# Access Compliance Report

### (Curb Ramps)

Intersection ID: 10025976	Main Street: ELM_LN	Cross Street: N/A	Location: SE
ADA ID: 108E2A43A810	Ramp Type: PerpDiag	Initial Pass/Fail: Fail	Overall Compliance: No
Codes/Mitigation Info/Possible Solution		Field Measurements/Component Compliance	
Severity Score: 12.5

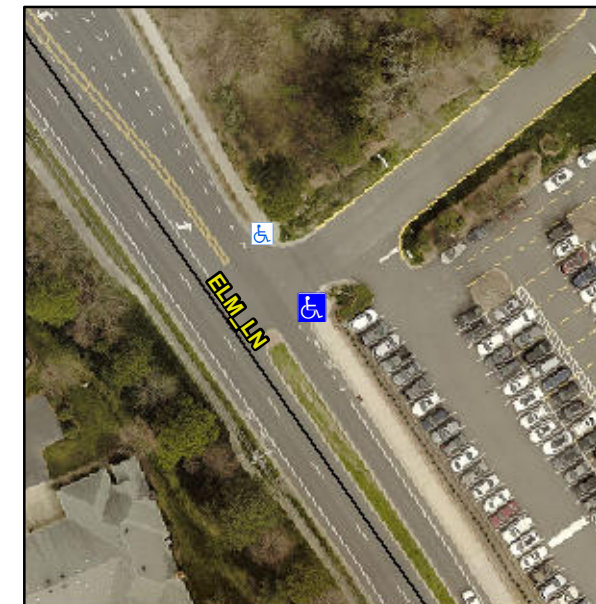
Compliance	Description	Data	Compliance	Description	Data
N/A	Ramp Length (in)	48.0	No	Ramp Slope (%)	8.7
Yes	Ramp Width (in)	48.0	Yes	Ramp XSlope (%)	0.5
N/A	Flare Type LT	N/A	N/A	Flare Type RT	N/A
N/A	Flare Slope LT (%)	N/A	N/A	Flare Slope RT (%)	N/A
N/A	Flare Traversable LT?	N/A	N/A	Flare Traversable RT?	N/A
N/A	Landing Length (in)	N/A	N/A	DWS Provided?	N/A
N/A	Landing Width (in)	N/A	N/A	DWS Contrast?	N/A
N/A	Landing Slope (%)	N/A	N/A	DWS Length (in)	N/A
N/A	Landing X Slope (%)	N/A	N/A	DWS Full Width?	N/A
N/A	Landing Curb? (Y/N)	N/A	N/A	DWS Offset (in)	N/A
N/A	Shared Landing?	N/A			
N/A	Gutter Ponding?	N/A	N/A	Gutter Slope (%)	N/A
N/A	Gutter Lip Ht (in)	N/A	N/A	Gutter X Slope (%)	N/A
N/A	Painted X Walk1?	No	N/A	Painted X Walk2?	No
	X Walk 1 Direction	To NW		X Walk 2 Direction	To SW
N/A	X Walk 1 Width (in)	N/A	N/A	X Walk 2 Width (in)	N/A
	X Walk 1 Slope (%)	0.7		X Walk 2 Slope (%)	0.8
	X Walk 1 X Slope (%)	1.7		X Walk 2 X Slope (%)	0.7

**Remove & Replace Curb Ramp With Two New Directional Ramps or Equivalent.**
